FMI ADMINISTRATIVE INFORMATION FMI No: 67601

FMI Title : Magnet Interface Replacement, MFO1 M4 Application Software Installation, and Patch Installation for Signa Ovation System

Magnet Interface Replacement, MFO1 M4 Application Software Installation, and Patch Installation for Signa Ovation System

**DIP SW SETTING OF NEW MAGNET INTERFACE UNIT
ILLUSTRATION 1**

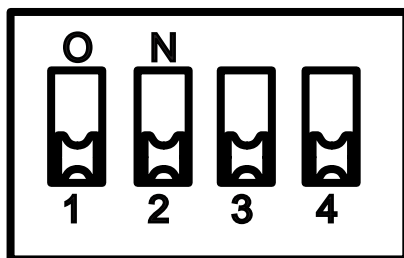
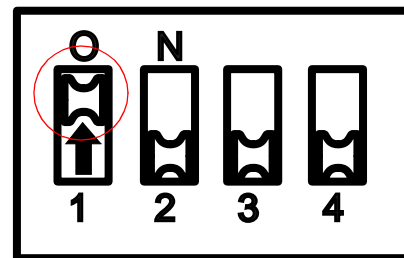
For new magnet interface unit (2254366-2), provide a bank of 4 dip switches including a function to select logic of OpenSpeed and Ovation, and this unit is keeping compatibility of OpenSpeed and Ovation by dip switch setting. Differential of logic is a signal condition for collision only.

1. Before installing the new unit, open the top cover of the New Magnet I/F unit by removing the 10 screws.
2. Slide switch 1 to ON position. Switch 2, 3 and 4 are OFF position.
3. Restore top cover of the magnet I/F unit with 10 screws.

**Switch 1 should be in the ON position,
2,3,4 are in the OFF position.**

**MAGNET INTERFACE ASSY REPLACEMENT
ILLUSTRATION 2**

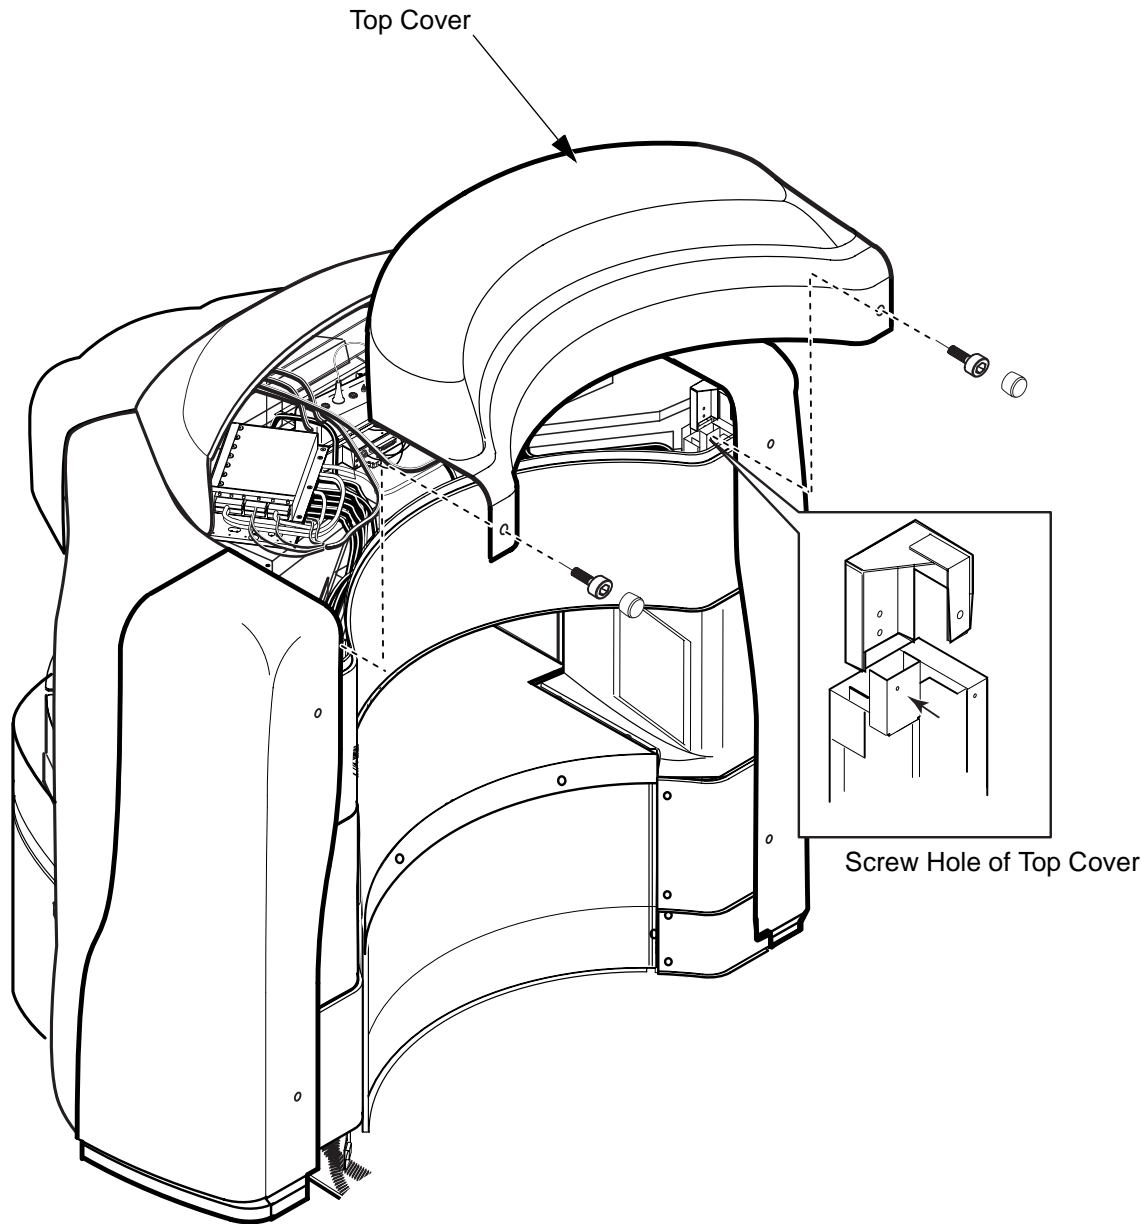
4. Remove the Top Cover by removing 2 screws and 2 caps.

MAGNET INTERFACE ASSY REPLACEMENT
ILLUSTRATION 3

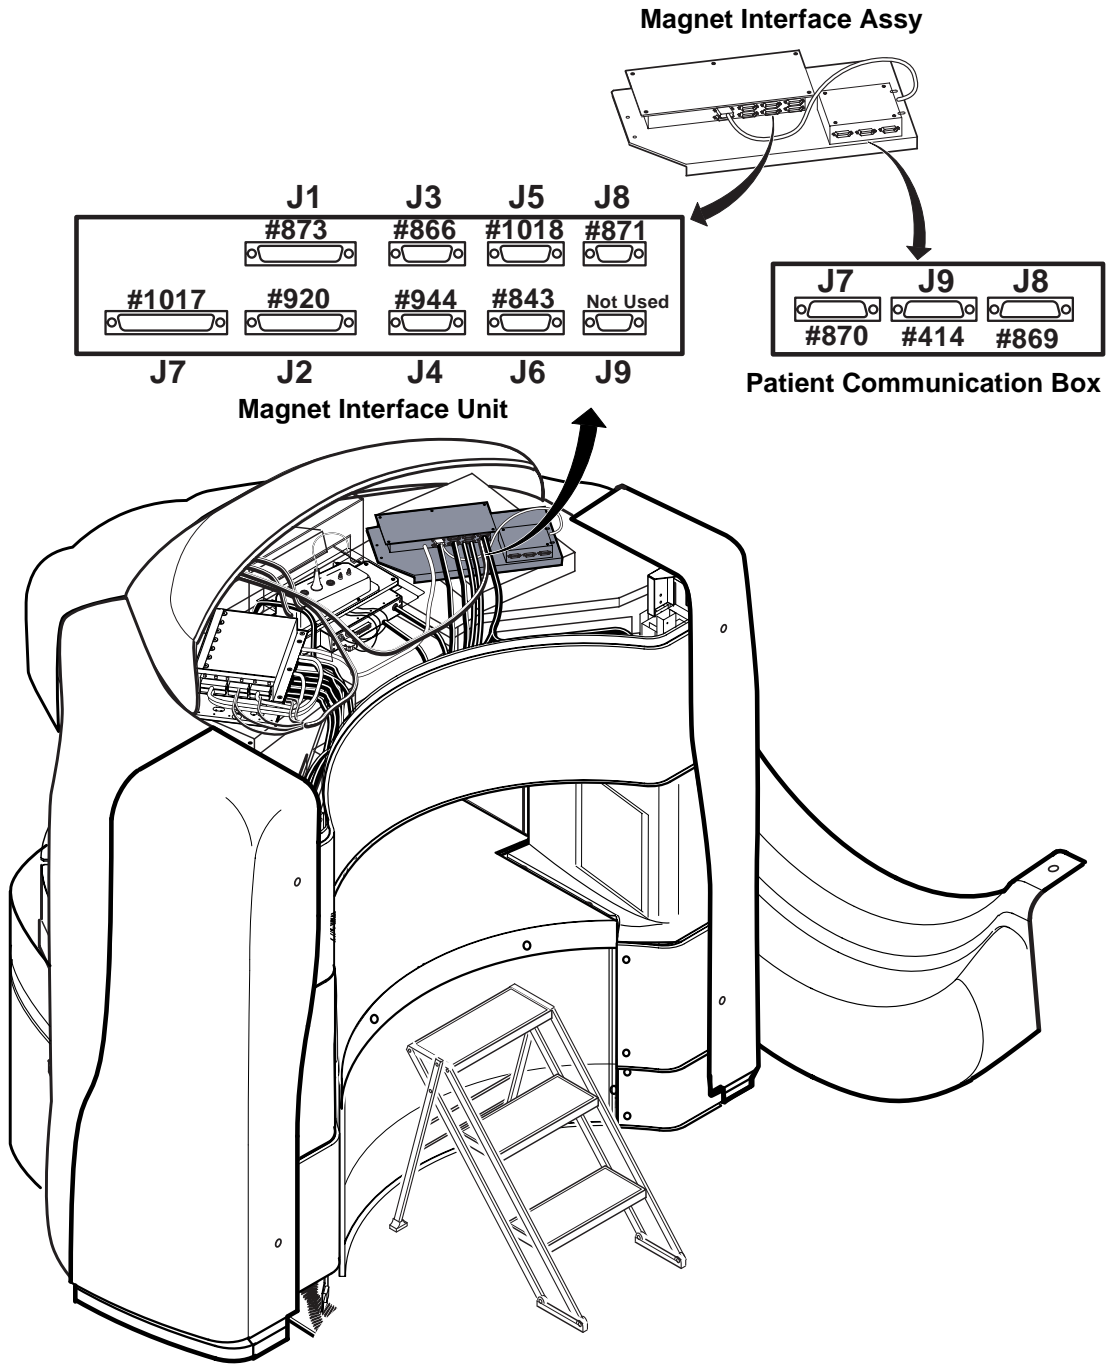
- 5. Disconnect the all cables from the magnet interface assy.

**MAGNET INTERFACE ASSY REPLACEMENT
ILLUSTRATION 4**

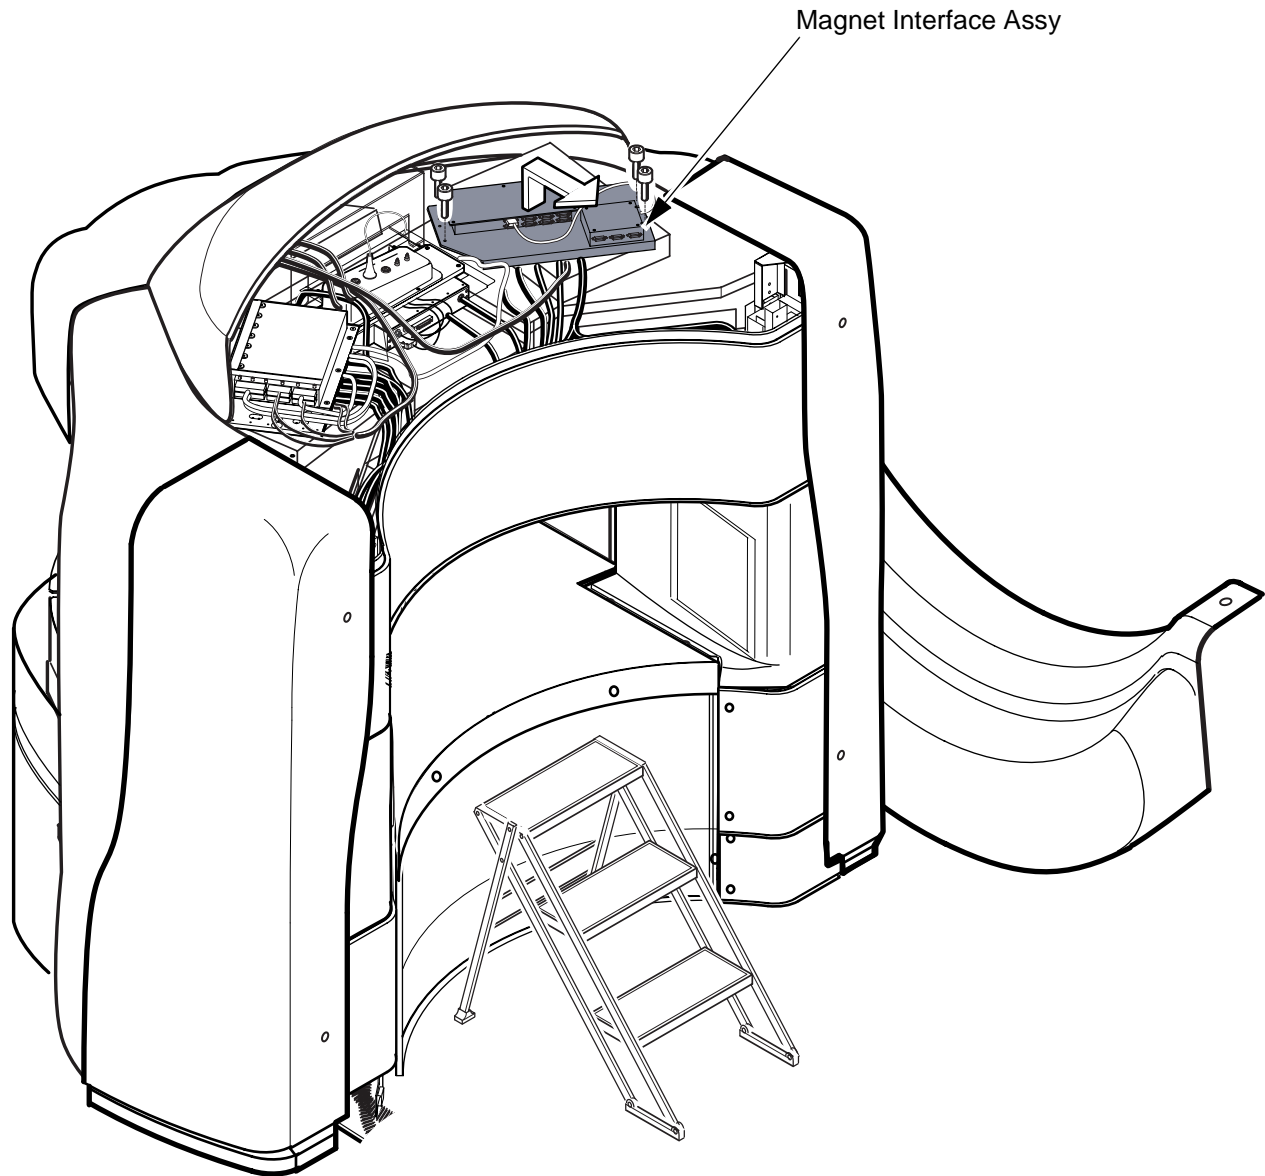
6. Remove the magnet interface assy from the magnet top by loosening 4 screws.

**MAGNET INTERFACE ASSY REPLACEMENT
ILLUSTRATION 5**

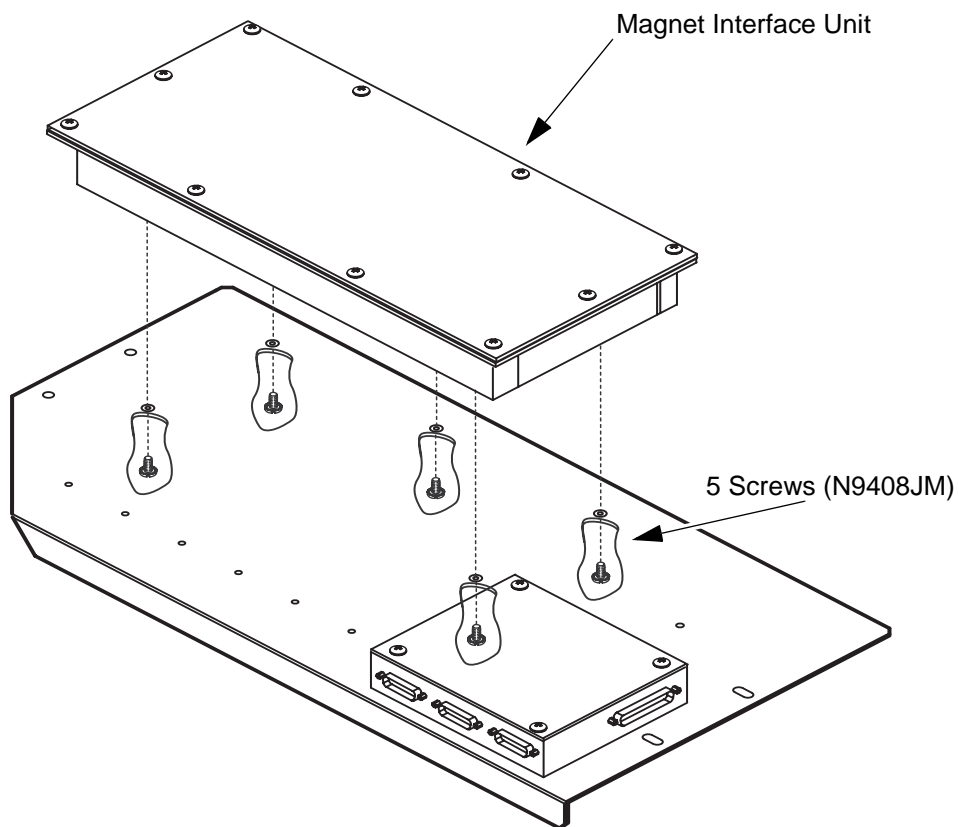
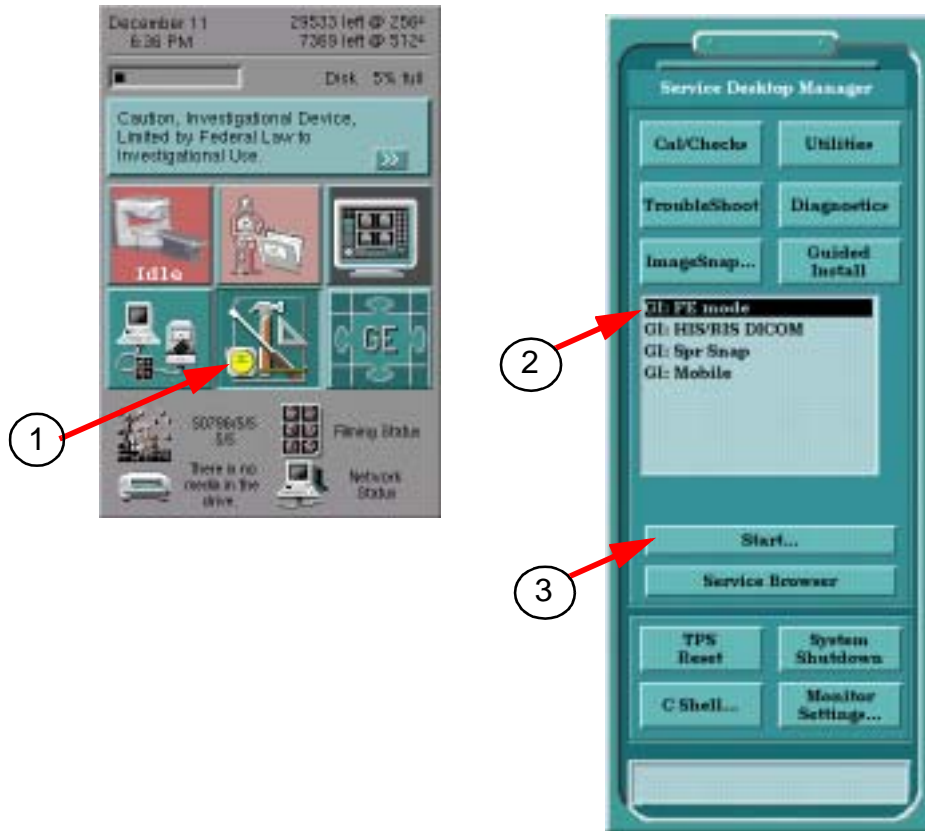
7. Remove the magnet interface unit from plate by loosening 5 screws (N9408JM).

8. Install new Magnet Interface Board by the reverse order of removal.

GUIDED INSTALL SCREEN
ILLUSTRATION 6

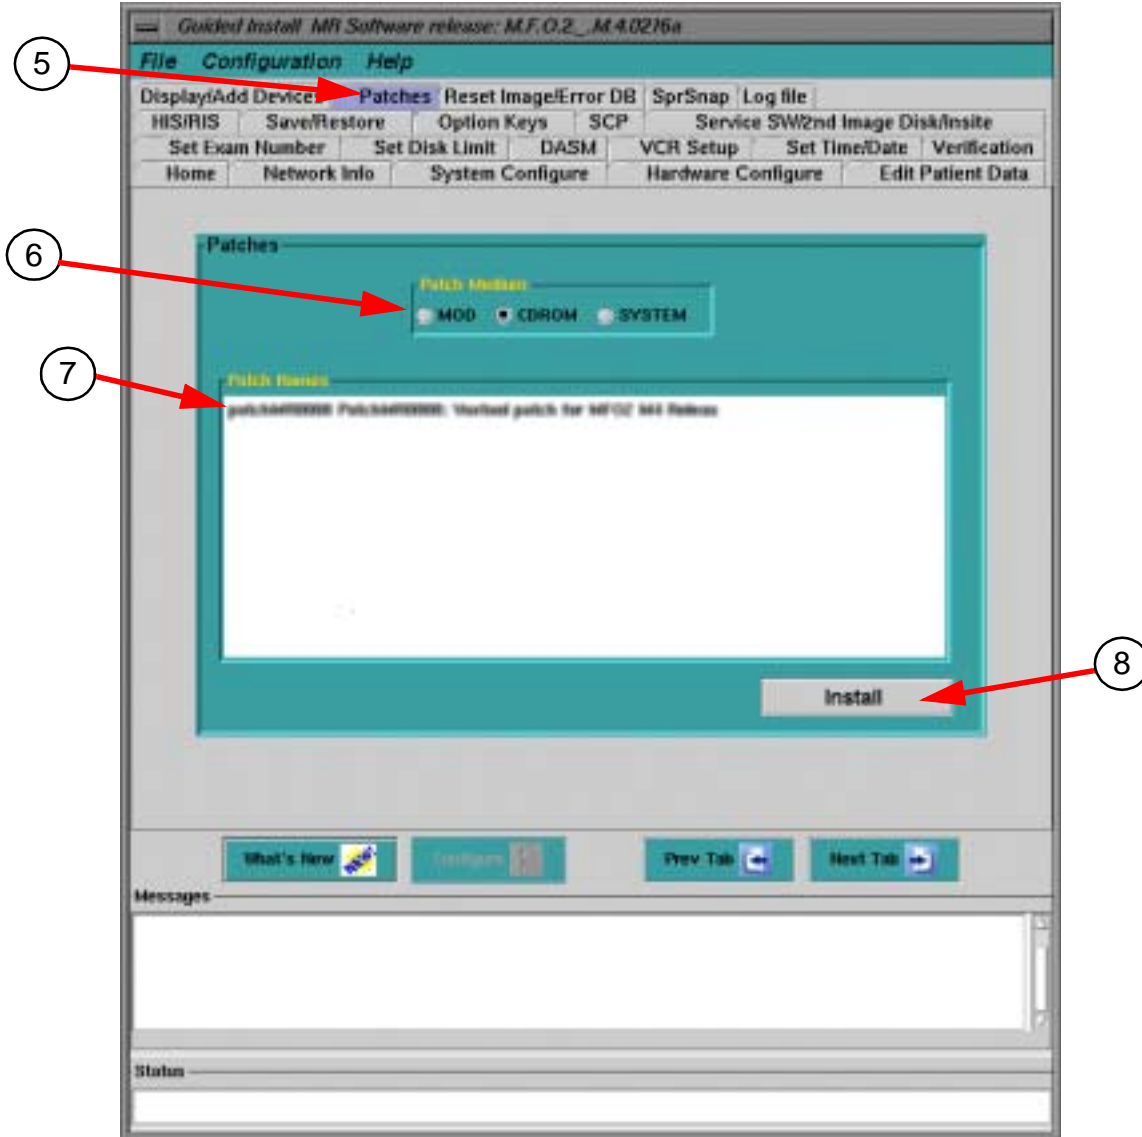
5. Guided Install Screen comes up. Click [Patch] tab.
6. Select Patch CD-ROM.
7. Select Patch Name.
8. Click [Install]. Patch Software will be installed.
